## Replacing SAC design clutch with conventional aftermarket replacement.

## Dual mass flywheel identification on Mercedes Sprinter

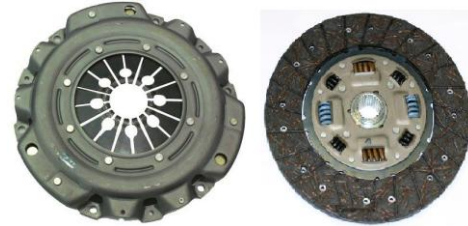
The enclosed parts differ in appearance to the original equipment design.

We have carried out stringent testing and evaluation to ensure the units are suitable alternatives.
